**WOKINGHAM
BOROUGH COUNCIL**

Discharge of condition Consultation

Site Address: Land west of Kingfisher Grove, Three Mile Cross

Proposal: Application for submission of details to comply with the following conditions of planning approval 201002 dated 31.01.2023

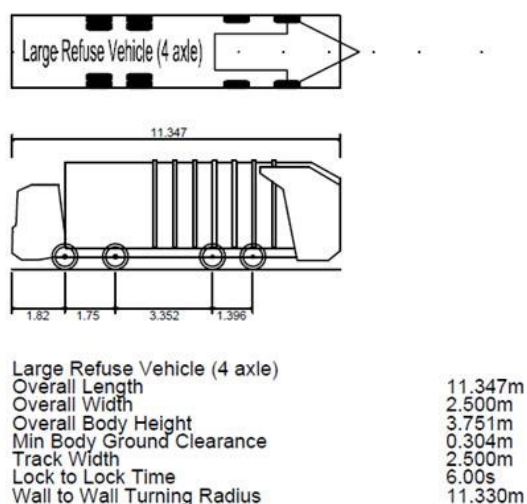
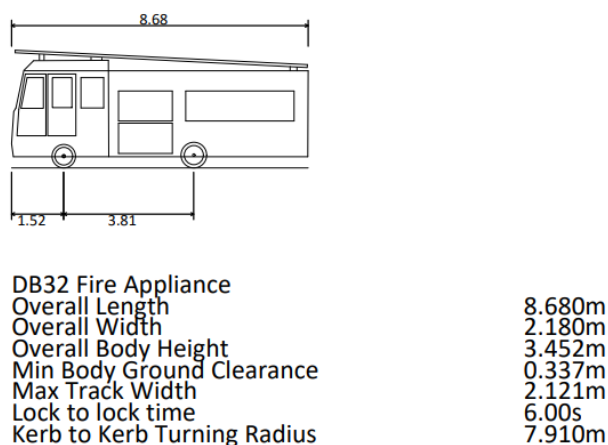
Paragraph 1.4.4 states that “Vehicle tracking confirms that a large refuse vehicle can enter and exit the site in forward gear”. This has not been provided. Vehicle tracking is to be submitted to show Refuse and Fire access into, circumnavigation of, and exit from site in the forward gear. The specifications for the design vehicles required are provided below:

Refuse Vehicle:

Fire Pump Appliance:

BOAT Location on Proposed Plan	BOAT Access on Google Streetview

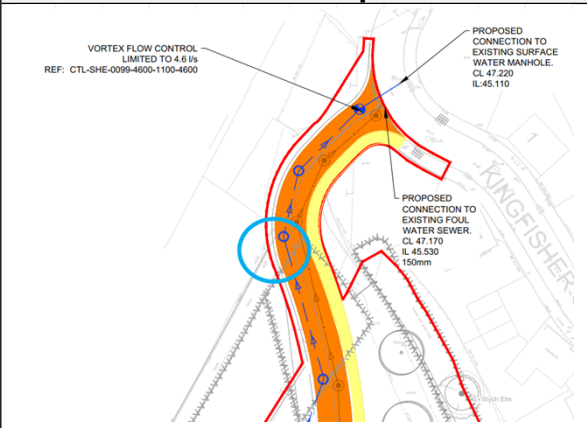
Details of the retained connection of the access to the public right of way (PROW) in the form of a Byway Open to All Traffic (B.O.A.T) where it meets the site access is to be provided (junction of site access and Kingfisher Grove).

To enable all users to safely access the PROW, dropped kerbs and a give-way line are required both on the southern kerb line (where the PROW meets the carriageway and on the northern kerb line to provide a crossing point from the 2.0m footway.

The applicant is also required to demonstrate a suitable visibility splay from where the PROW joins the site access. This is to ensure vehicles, cyclists, horseriders or pedestrians have suitable visibility of vehicles.

The location of concern is circled in blue below within a screenshot and a google maps image:
